Type Coffee Vending Machine	Model 7300	T.I. NO 09 - 2015		
Serial Number 51611589	Subject CUP TURRET MODIFICATIONS	ISSUED FOR (X)	Action Information	X

With the aim to improve our equipment, it has been introduced a **new CUP TURRET**

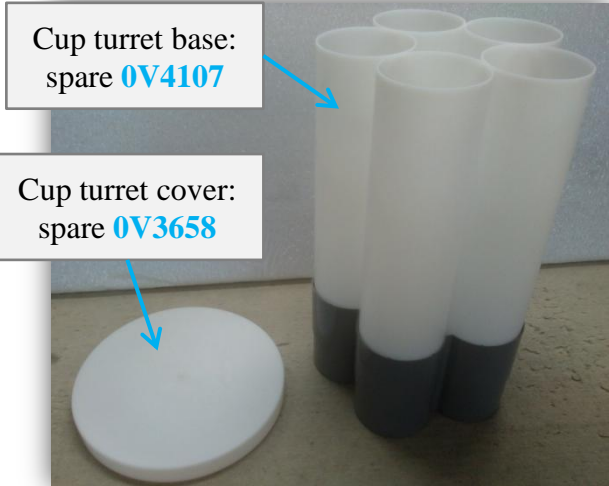
Old cup turret - Spare 39574000

New cup turret - Spare 252268

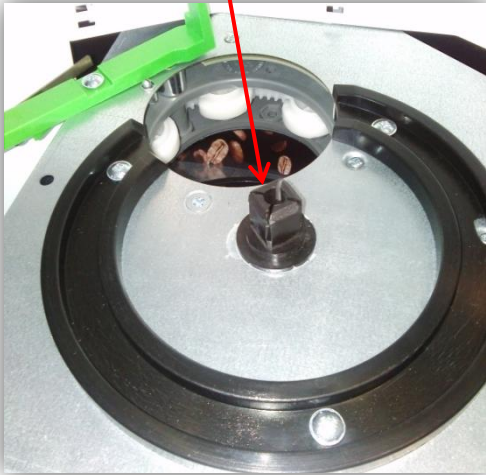
The *new cup turret* requires a **new cup column pin**

Old cup column pin
Spare code: **39574000**

New cup column pin
Spare code: **258610**

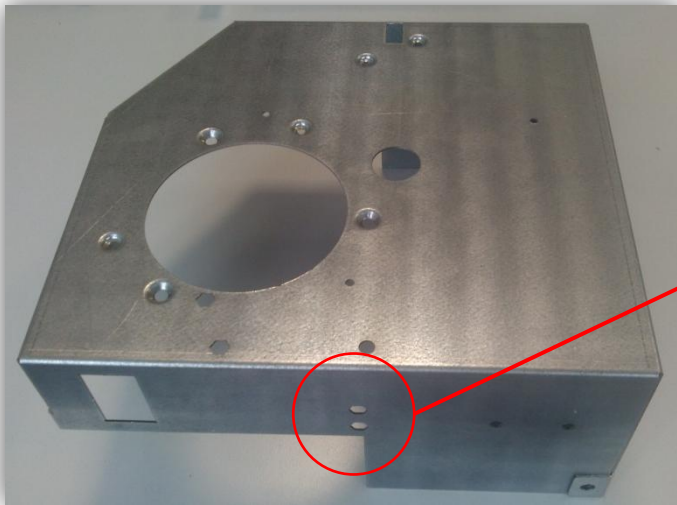
New *cup turret* : it has been added an **hexagonal cut** in the “*top for cup dispenser*”. This cut is the housing for a second pin M4 x 10.
The second pin guarantees the correct cup turret stability during cups refilling

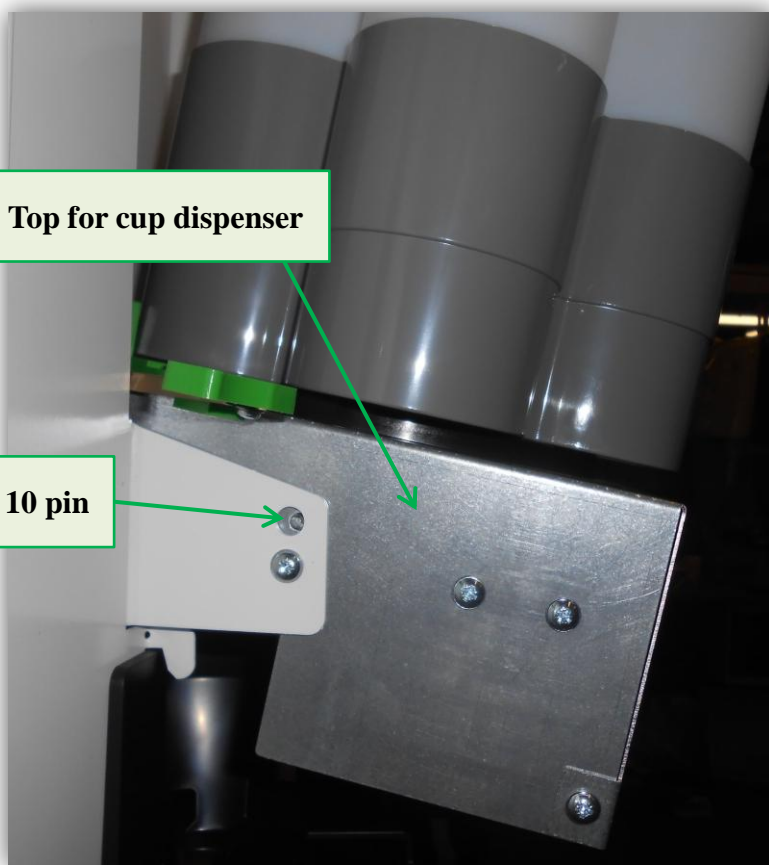
New *cup turret* - The pin M4 x 10 , added in the “*top for cup dispenser*”, guarantees the correct cup turret stability during cups refilling.
